Preliminary Consultation
MONTGOMERY COUNTY HISTORIC PRESERVATION COMMISSION
STAFF REPORT

Address:	3 Primrose Street, Chevy Chase	Meeting Date:	3/24/2021
Resource:	Contributing Resource Chevy Chase Village Historic District	Report Date:	3/17/2021
Applicant:	William Curtin Outerbridge Horsey, Architect	Public Notice:	3/10/2021
Review:	Preliminary Consultation	Staff:	Dan Bruechert
PROPOSAL:	Building Modifications

DRAWING TITLE:
**PROPOSED FLOOR
PLANS**
SCALE: AS NOTED

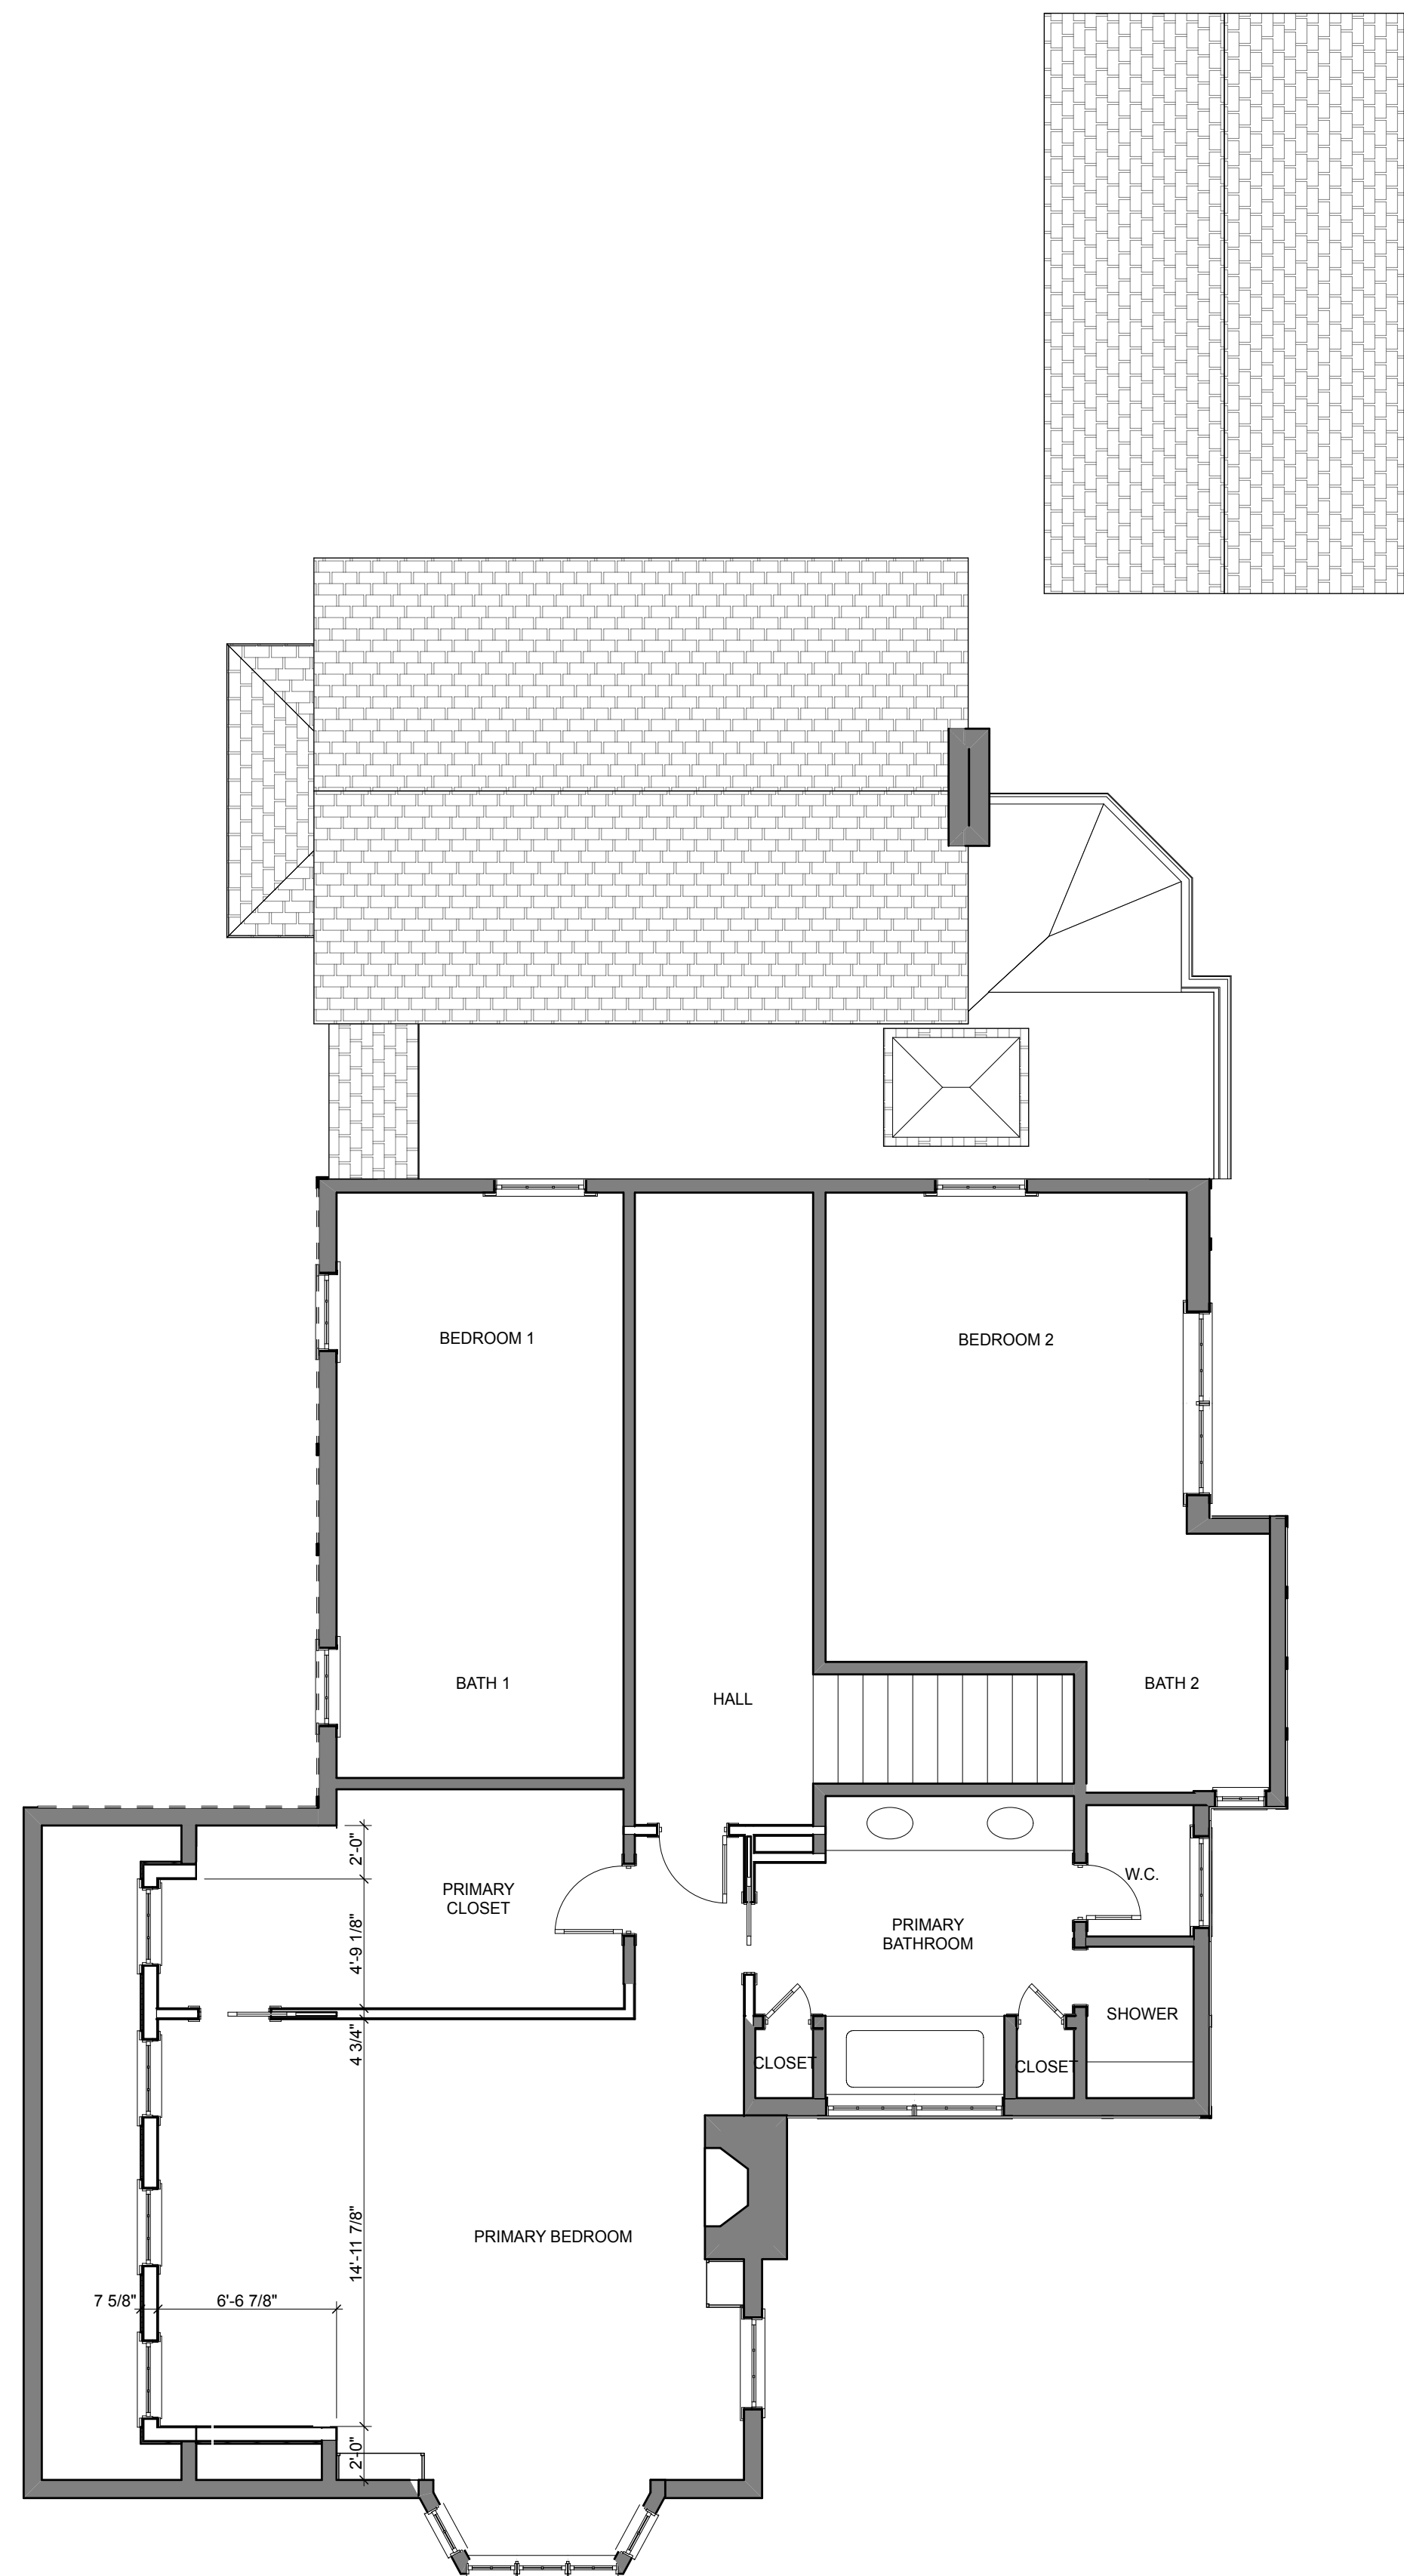
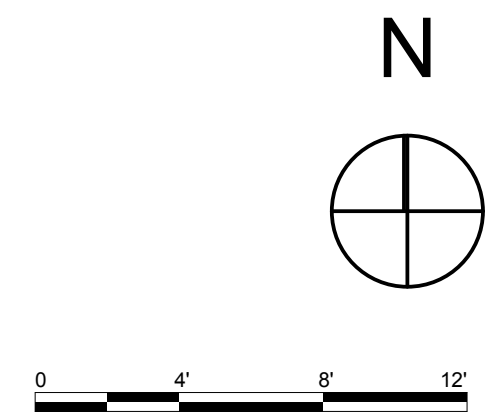
roof projecting to the right. While the scope of work identified above includes three items, Staff finds that the new rear vestibule and window assembly on the east elevation are toward the rear of the house, are not visible from the right-of-way, and should be approved when they come in for a HAWP as these alterations are designed in a compatible manner constructed of appropriate materials. The primary area under consideration for this preliminary consultation is the construction of a dormer on the left (west) roof slope of the front, asymmetrical gable.

- Whether a dormer can be supported under the *Design Guidelines*?
- If the Commissioners support one design over the others? Or
 - If the Commissioners find one design to be incompatible with the historic character of the house or the surrounding district.
- Any comments on the alterations to the window assembly or rear vestibule.
